Your Ref SSD-64916225
Our Ref NCA/19/2023
Contact Darren Wan
Telephone 9806 5565
Email dwan@cityofparramatta.nsw.gov.au

**COUNCIL SUBMISSION
EXHIBITION OF AMENDED STATE SIGNIFICANT DEVELOPMENT APPLICATION – WSU
INDIGENOUS CENTRE OF EXCELLENCE (171 VICTORIA ROAD, PARRAMATTA)**

Attachment 1 – Flood Modelling Requirements

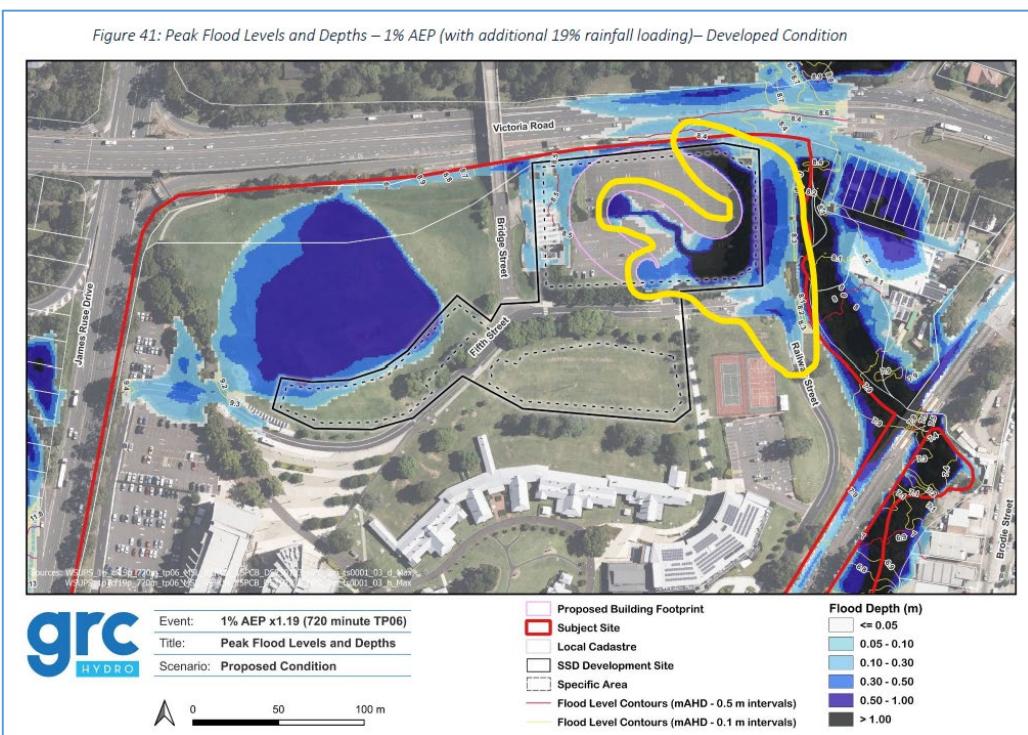
- i. **Rainfall Intensity and Temporal Pattern** : The 19% increase in rainfall intensity (with the highest temporal pattern) appears to have only been used in sensitivity analysis.

This increment and temporal pattern should be included in the base case/design case for all design, flood impact assessment, and flood planning level calculations, as this allowance is for Flood Frequency Analysis calibration and is adopted.

Figure 36: Flood Level Impact – 1% AEP – Developed Condition Minus Existing Condition

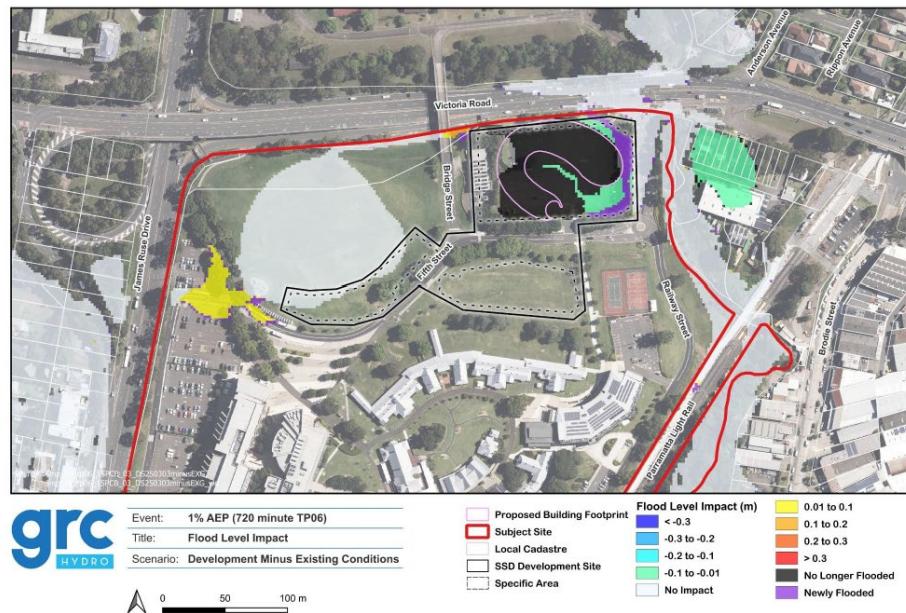
- Clarify if the assessment includes the 1%AEP + 19% rainfall increment with highest TP.
- Removing flood storage is unlikely to have no impact—provide evidence.
- Address the cause of the 10–100 mm flood afflux on the western side; ensure no worsening of existing flooding.
